UNITED STATES PATENT AND TRADEMARK OFFICE

Office Action Summary

10/765,391

DETAILED ACTION

FIG. 6

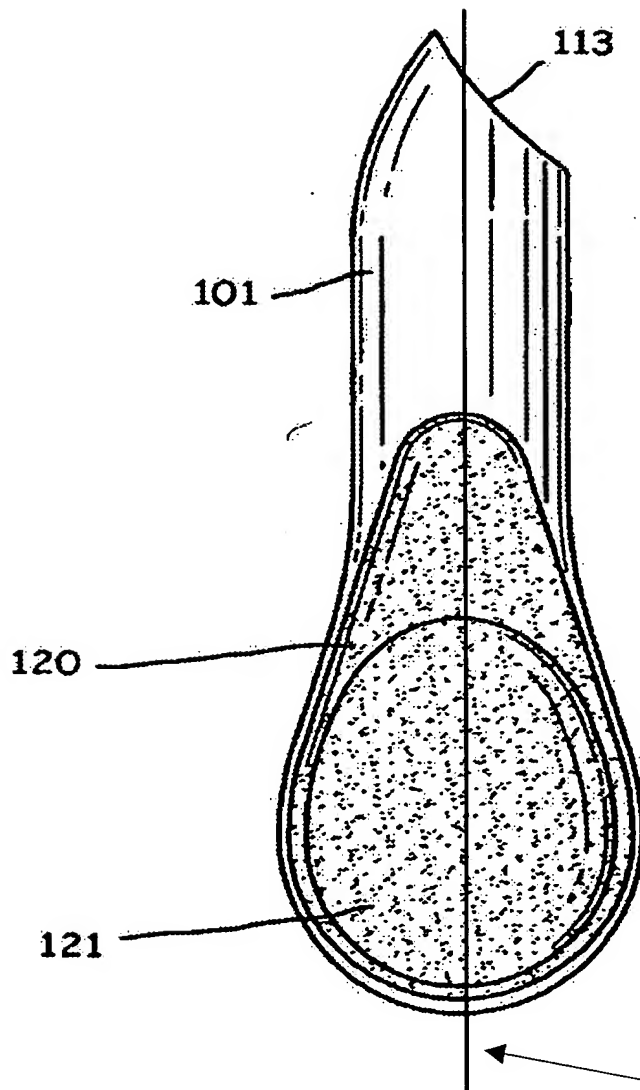
Regarding claim 6, claim 6 states the lever having a thumb accepting depression. However, it appears in Figs. 5 and 6 that the thumb accepting depression is on the top member 101. It is unclear when one clips his nails, does he applies force on the lever 118 or the top member 101 since in a conventional clipper one would apply force on the lever.

Regarding claim 8, claim 8 states the cutting edges 113 being offset from a central longitudinal axis of the top and bottom members. However in Fig. 6 the cutting edges are on the central longitudinal axis of the top and bottom members. It is unclear where the location of the cutting edges is.

Central longitudinal axis
